# Report to the Future Melbourne (Planning) Committee

Agenda item 6.1

Ministerial Planning Referral: TPMR-2019-25

52-60 Collins Street, Melbourne

TP02.00

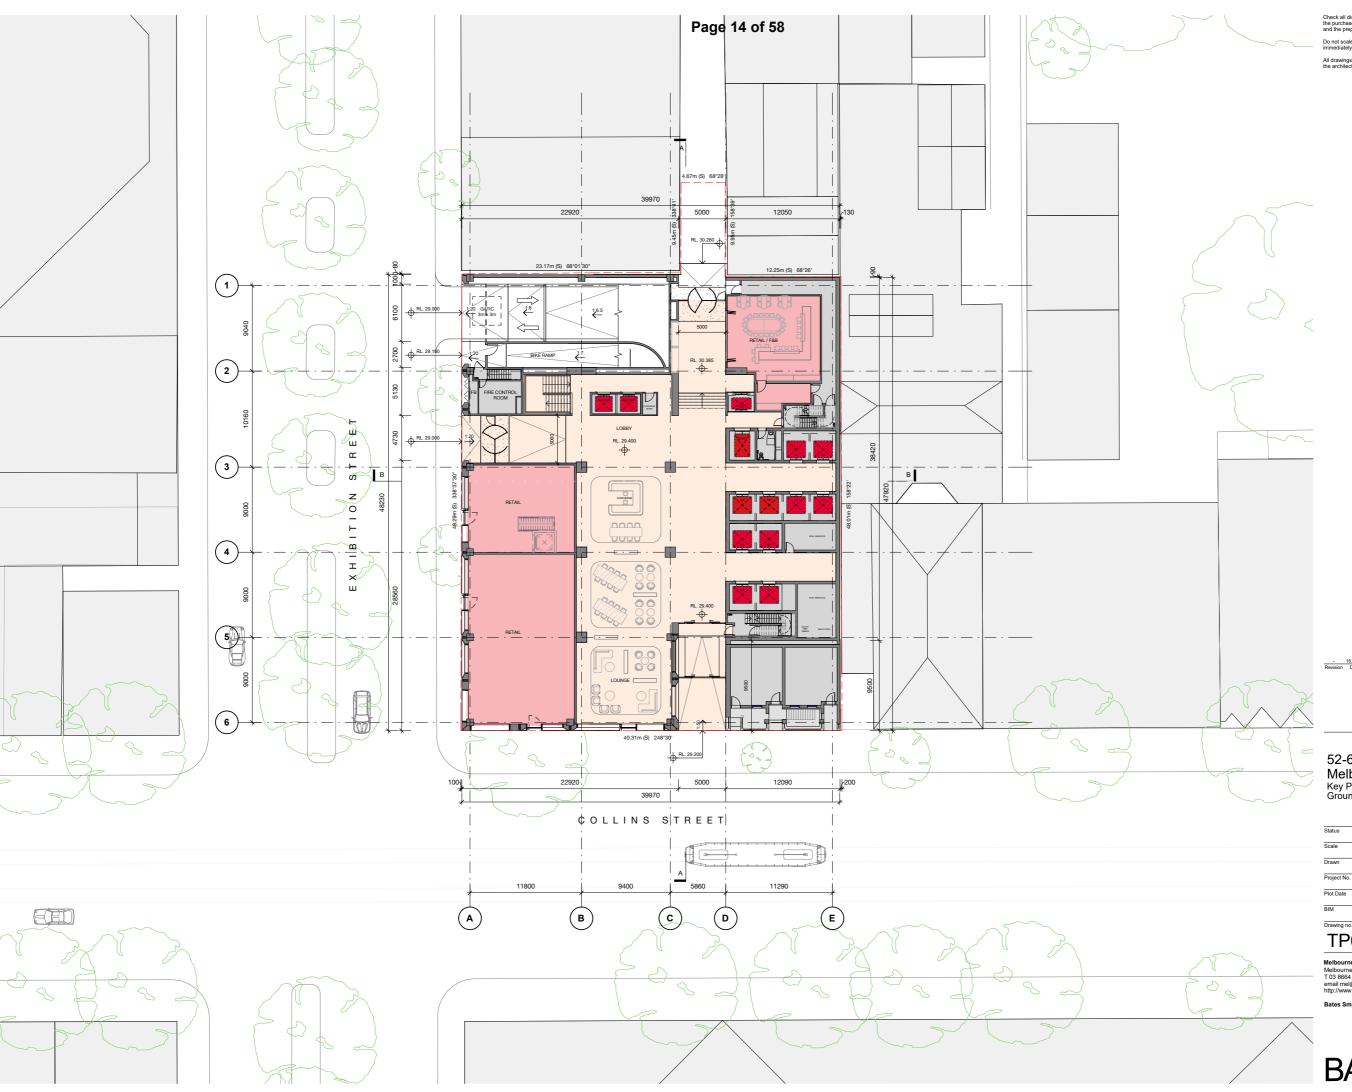
Figure 6 below shows the ground floor layout of the building, including the proposed linkway.

Figure 6: Ground floor layout (source: Bates Smart submitted architectural plans)

The development would provide a through-block link and as such reduces the effective width of this block as well as provides for a new and convenient pedestrian connection.

# SHADOWS SEPTEMBER

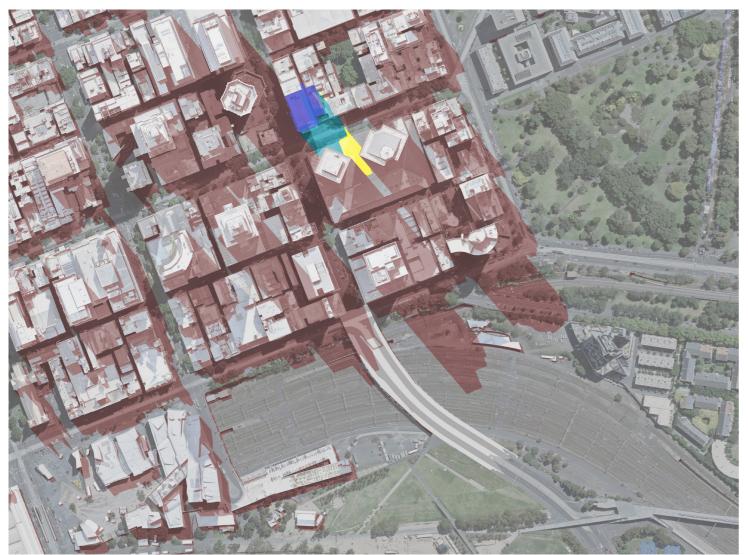
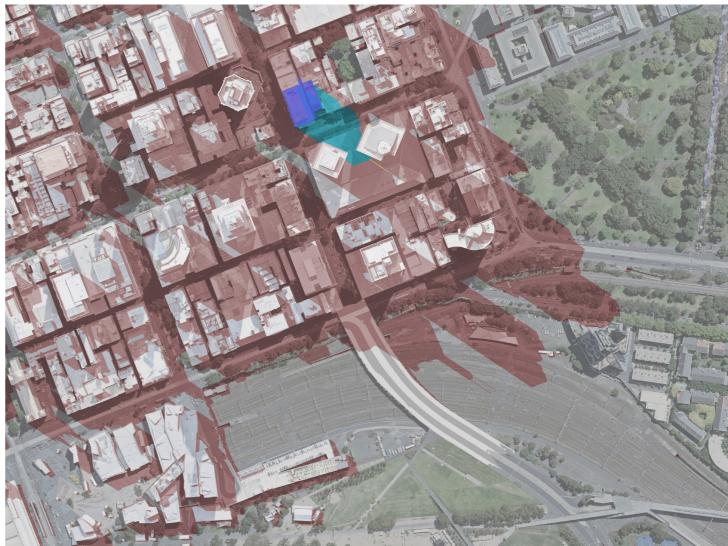
Table 1 of Schedule 10 lists those public places which must not be overshadowed on specific dates and times. Shadow diagrams submitted in support of the application show that the proposed building would not overshadow these spaces on the dates / times specified in Table 1 and as such the development accords with the provisions of this element of the schedule.

Figure 7: The approved redevelopment of the Collins Place forecourt

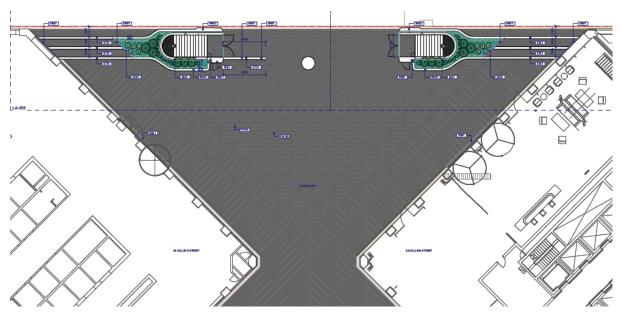
Importantly, a permit has recently been issued to redevelop the forecourt (refer Permit TP-2018-736). This would result in the general opening up of the forecourt by way of the demolition of existing structures within it and the provision of feature lighting suspended from the glazed roof above. Figure 7 overleaf shows the approved works in greater details. It is considered that these works only reinforce the importance of the forecourt as an open public space which warrants protection in accordance with the provisions of Schedule 10 of the DDO.

Figure 8: The extent of the shadows cast over the publicly accessible forecourt of Collins Place on 22 September at 2pm (source: Dexus submitted shadow studies)

A more tempered form on site, better responding to the heritage constraints of the surrounding area, would have the added benefit of reducing the length of shadows cast over the forecourt of Collins Place. This, in turn, could then satisfy the requirements of Schedule 10 of the DDO as these relate to the overshadowing of public spaces. Importantly, Schedule 10 does not prohibit the overshadowing of public spaces such as this forecourt. Shadows must however not be 'unreasonable'. Though a specific metric does not exist for this, Schedule 10 is clear that the amenity of the forecourt must not be unreasonable prejudiced.
